WATER PERMIT NO. 9029-3

**RECOMMENDATION OF ACTING CHIEF ENGINEER FOR WATER PERMIT
APPLICATION NO. 9029-3, Craig Vanderlei**

Report to the Chief Engineer
On Water Permit Application No. 9029-3

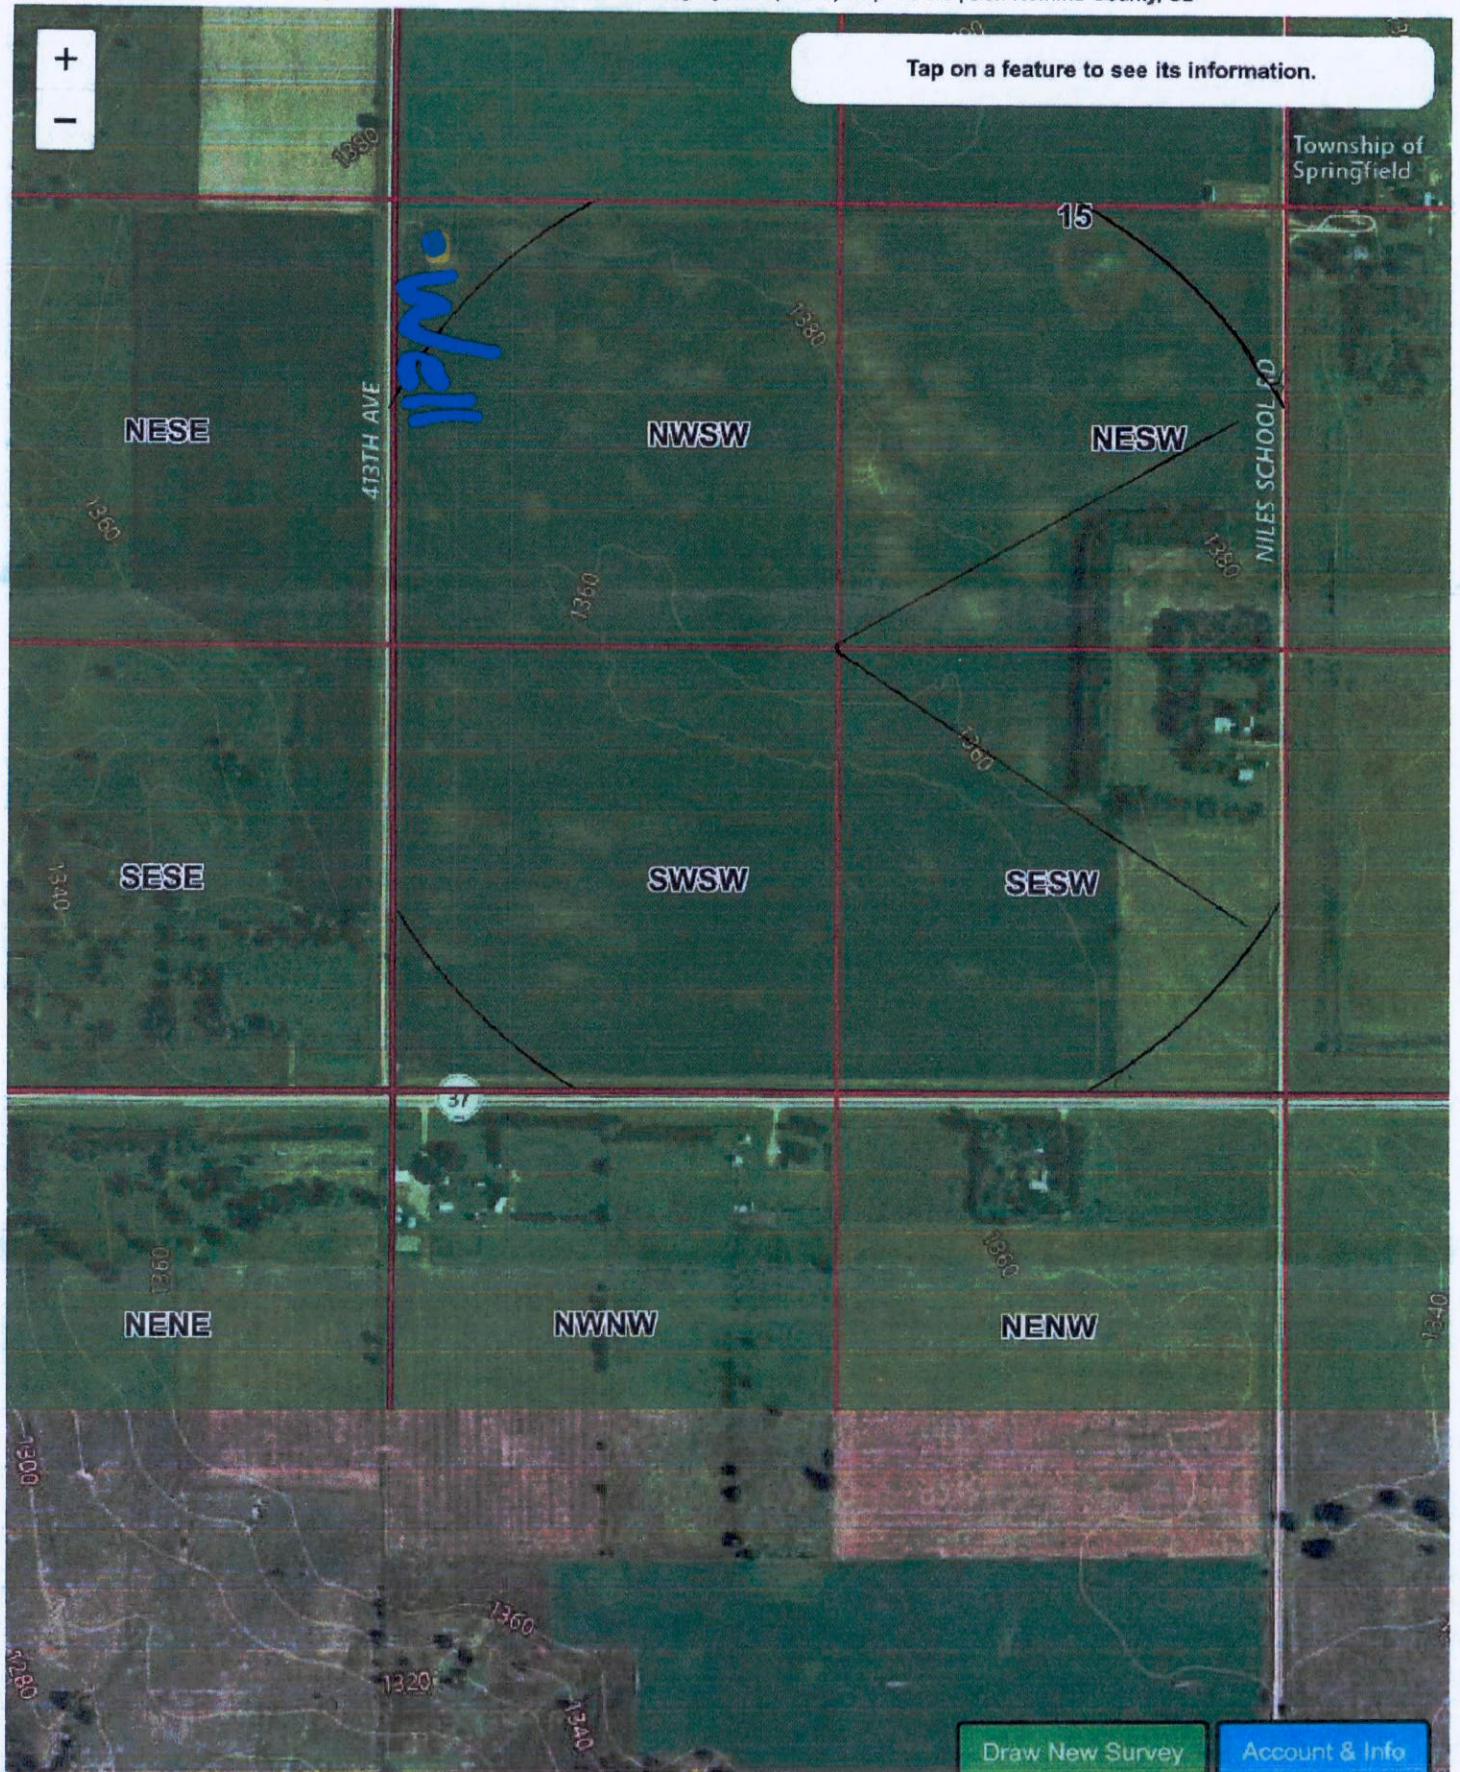
Your application looks good. On the map, I just need you to mark the well location with an "X" and return to me.

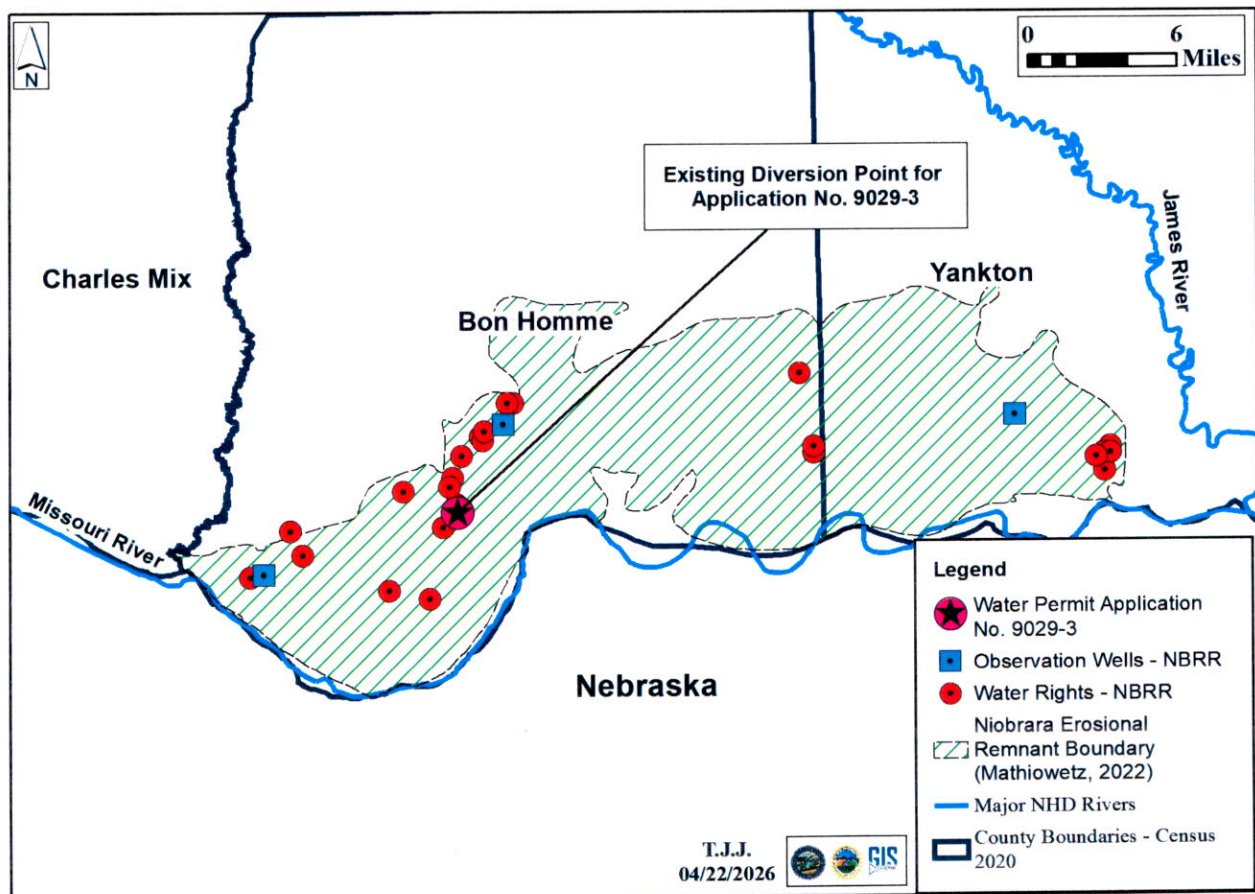
The DANR-Water Rights Program monitors three observation wells completed into this erosional remnant of the Niobrara aquifer. Of those observation wells, YA-2020A, was installed in 2020 and has a limited period of record, so the usefulness of the data is limited for evaluating long term water availability. The observation wells provide data on how the aquifer reacts to regional climatic conditions and local pumping. The three observation wells completed into this erosional remnant of the Niobrara aquifer are BH-82E (approximately 8.2 miles southwest), BH-82C (approximately 4.0 miles northeast), and YA-2020A (approximately 23 miles northeast) (Water Rights, 2026b). The locations of these observation wells are displayed in Figure 1 (Water Rights, 2026b).

Figure 2. A hydrograph showing the elevation of water levels of observation wells in this erosional remnant of the Niobrara aquifer (Water Rights, 2026b)

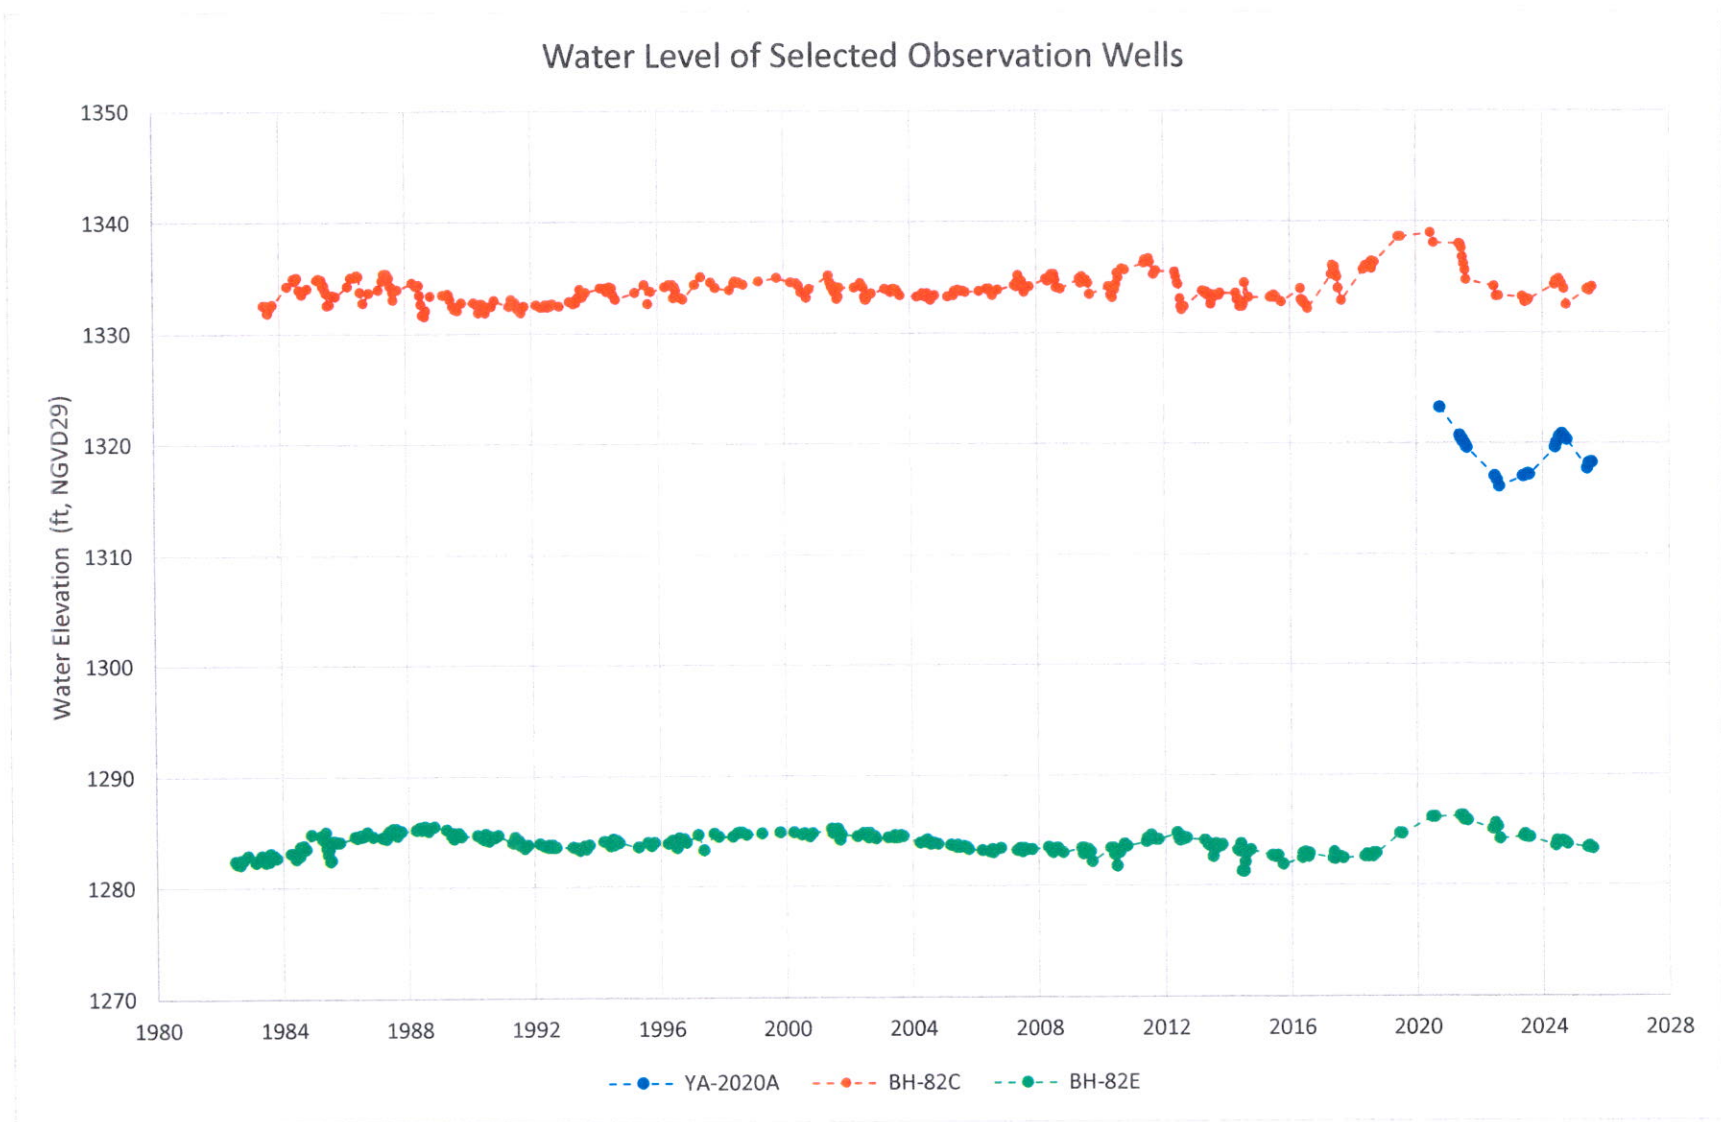
The hydrographs in Figure 2 display stable to slightly increasing water levels in this erosional remnant of the Niobrara aquifer over their periods of record. Several observation wells in close proximity to irrigation wells show localized seasonal dips in measured water levels during the irrigation season in response to pumping and recover to pre-pumping levels in the spring (Water Rights, 2026b). The observation well data show that climatic conditions (NOAA, 2026), and therefore natural discharge from and recharge to the aquifer, govern the long-term fluctuations in water level. Since recharge to and natural discharge from an aquifer can be captured for pumping, there is a reasonable probability that unappropriated water is available from this erosional remnant of the Niobrara aquifer for the proposed appropriation.

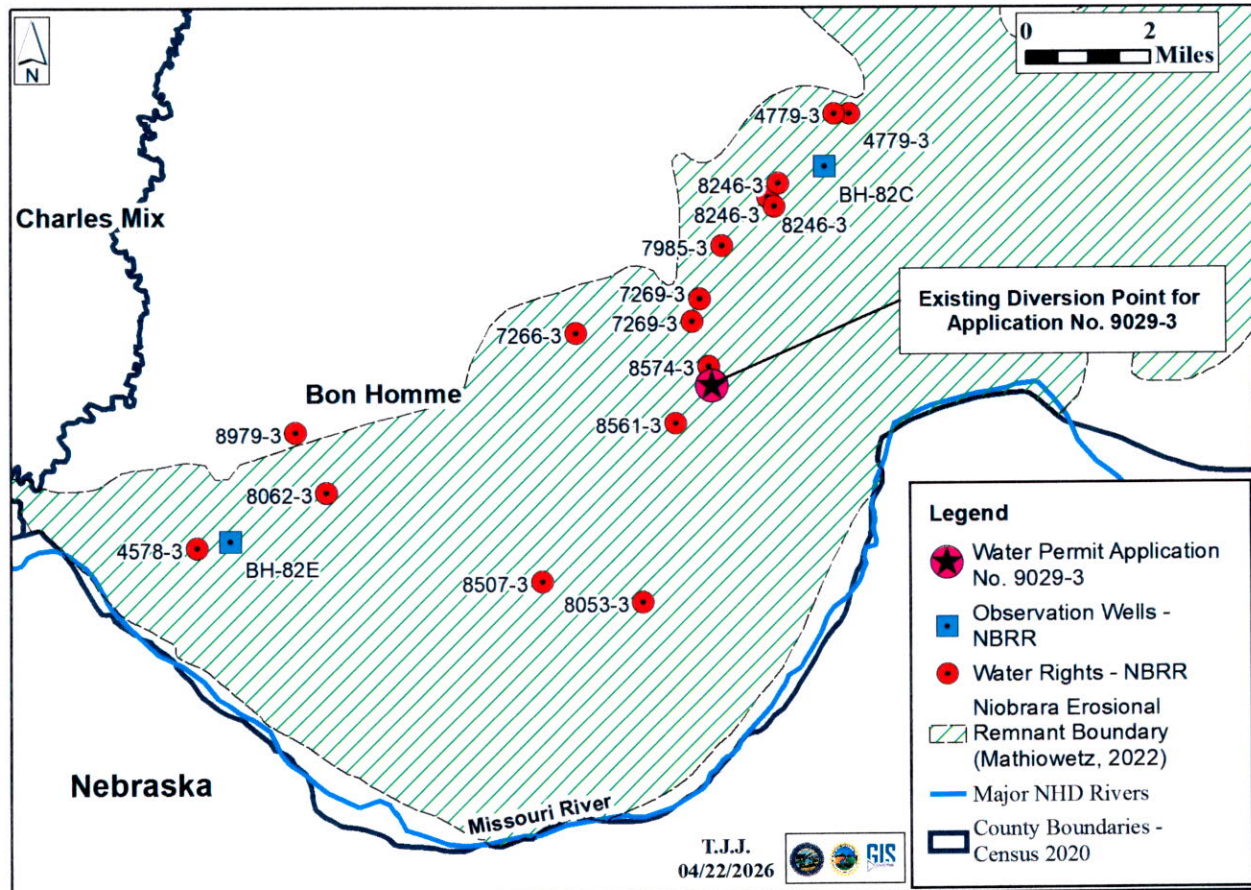
Water rights/permits in the general vicinity of the existing diversion point for this application are shown in Figure 3 and summarized in Table 4 (Water Rights, 2026c). The closest water right/permit to the existing diversion point, not held by the applicant, is Water Right No. 8574-3 held by Ivan Jelsma as shown on Figure 3. The diversion point for Water Right No. 8574-3 is located approximately 0.3 miles north of the existing diversion point for this application (Water Rights, 2026c). There are domestic wells on file with the DANR-Water Rights Program that are completed into the Niobrara aquifer, with the closest domestic well on file (not held by the applicant) located approximately 0.1 miles northwest of the existing diversion point based on the well completion report submitted by the driller (Water Rights, 2026d). There could potentially be other domestic wells completed into the Niobrara aquifer near the existing diversion point that are not on file with the DANR-Water Rights Program. The location of the domestic wells in the well completion report database maintained by the Water Rights Program is based on the location listed by the driller on the well completion report.
